## Ref St Cuthberts, Wells - Lighting Faculty

Following receipt of the email outlining feedback from the Dac meeting on 14<sup>th</sup> January please find my comments and response as promised.

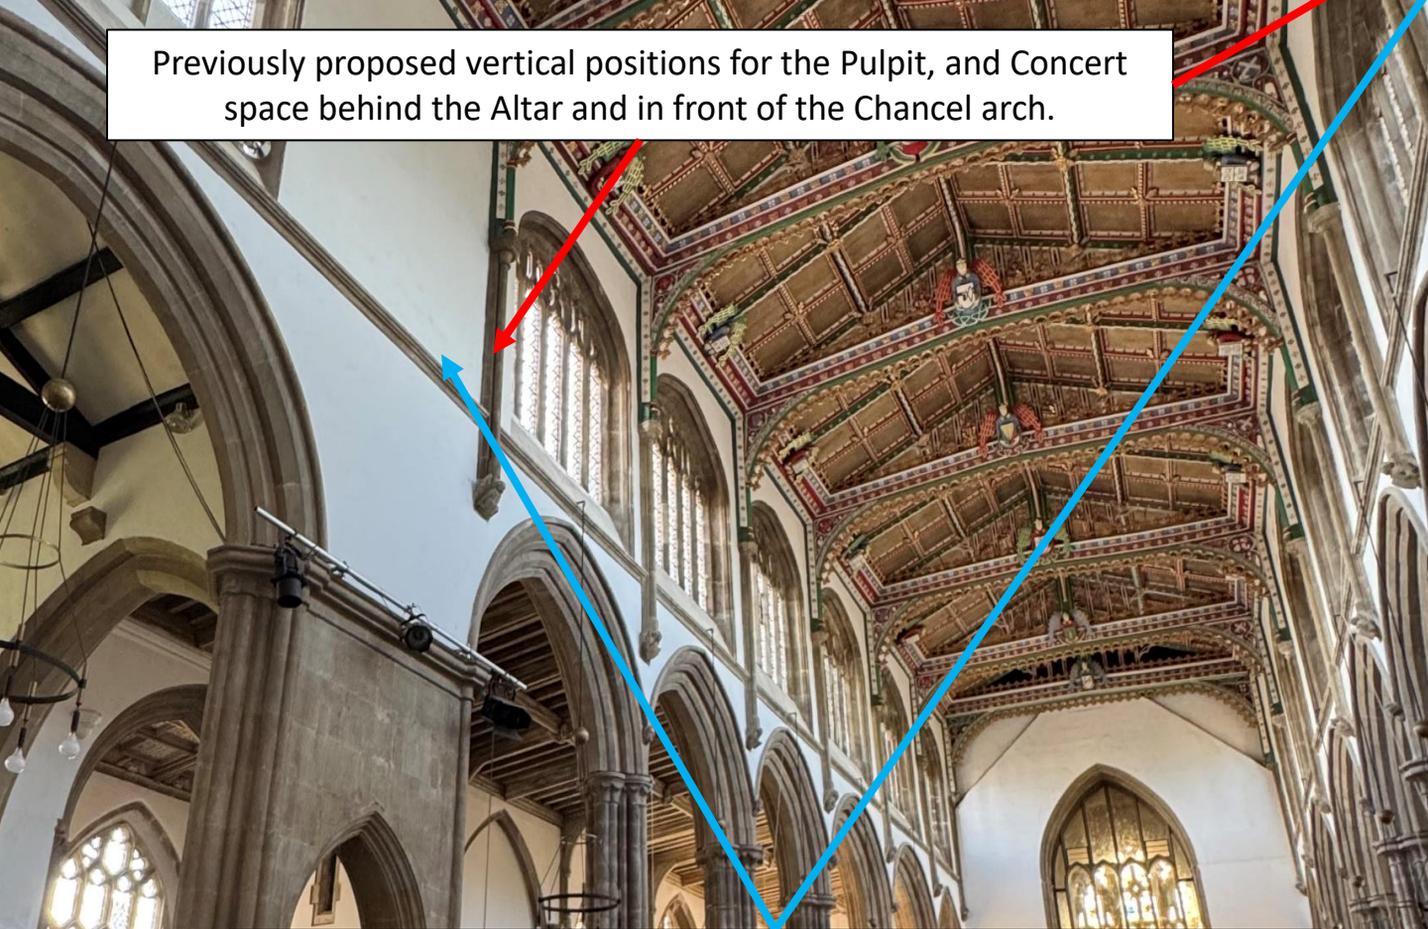
**Bullet Point 2** – The first paragraph here is a little confusing as far as I can see the height of the fittings will have no bearing over additional/depth of shadows over the celebrants or performers as these would be decided on the angles of the light falling across the faces.

I believe that the angle of the new lights would be more beneficial as they would be at a shallower angle and not a steeper one and this is shown on the following page, I am also confident that the proposed positions will not produce unwanted glare.

The second paragraph – If the advisor feels that the luminaires for the pulpit, relevant Lectern and concert space in front of the Chancel arch etc should be mounted horizontally as opposed to vertically (as shown on the following page) then it will make no difference to the overall effect.

Third paragraph - hopefully the following page will show that the current positioning for the Nave Altar is in the appropriate place but again, if required this could be demonstrated to the inspecting architect during the course of the works.

I suggest that the shallower angle of the light falling across the face of the celebrant and others stood in this area will produce less and softer shadows than the existing positions whilst not causing unacceptable levels of peripheral glare.

Proposed positions for the Altar and celebrant spotlights

Existing positions of the Altar and celebrant spotlights.

Previously proposed vertical positions for the Pulpit, and Concert space behind the Altar and in front of the Chancel arch.

Proposed revised horizontal positions for the Pulpit, and Concert space behind the Altar and in front of the Chancel arch.
